BCA Assessment Report

78 Lockwood Road Data Centre
78 Lockwood Rd, Erskine Park

Revision 2

18 August 2025

Figure 2 – Undercroft link between eastern & western portions of Large Isolated Building

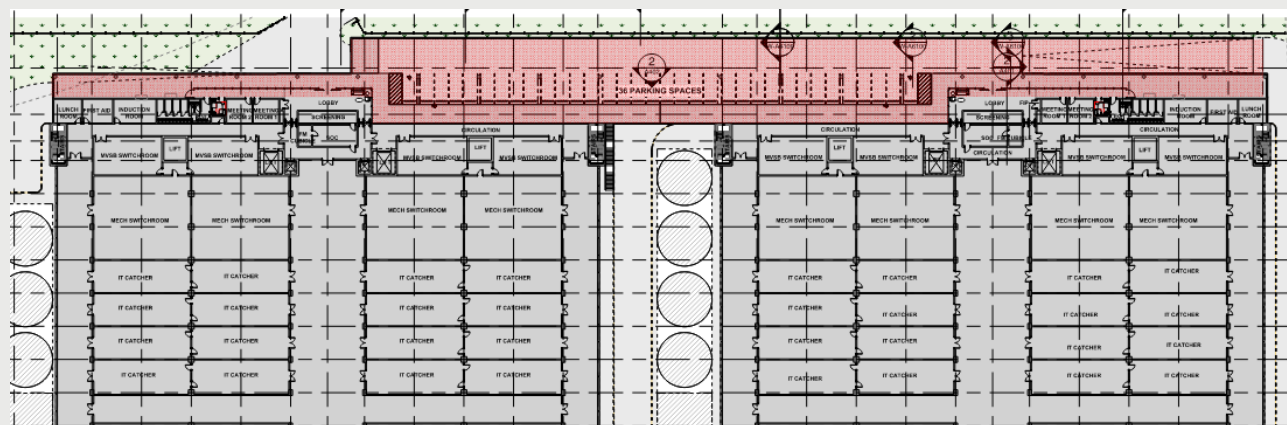
Note 2: Large Isolated Building – The eastern and western portions of the main Data Centre building are connected at the Lower Ground Level by the external carpark slab over (see Fig 2 below). As a result they have been assessed as a single Large Isolated Building pursuant to

Figure 4 – Fire Wall Locations

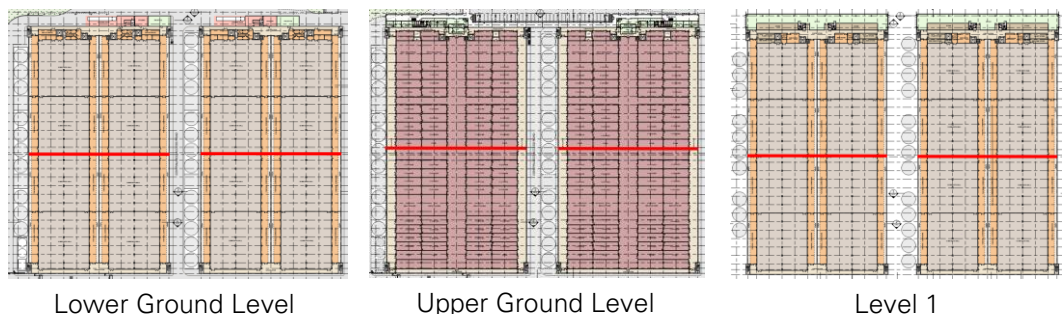
Comment: As noted in C3D4 above the main Data Centre building has been assessed as a Large Isolated Building, however, Fire Walls are required. To provide Horizontal Exits to address non-compliant egress distances. The proposed Fire Walls are identified in Figure 4 below and are required to comply with C3D8(1) & (3) - details to be included on the CC Application Plans. Note: See comments under D2D5 and D2D16 below in relation to egress distances and Horizontal Exits.

Figure 5 – Roof as Open Space

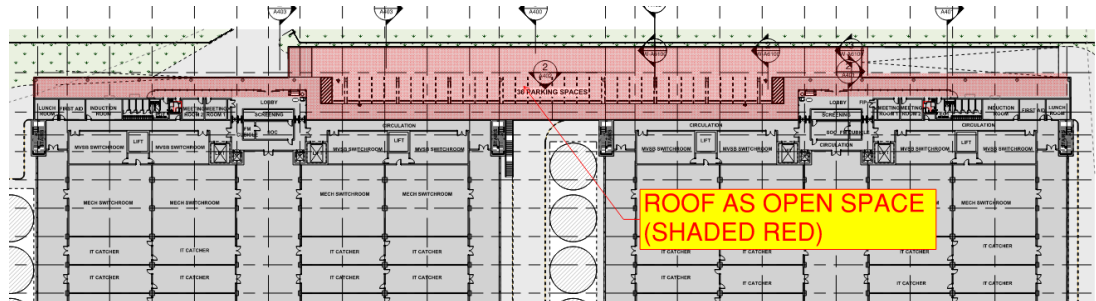
Comment: The external carparking area on the northern side of the Upper Ground Level is considered roof as open space in accordance with D3D13.
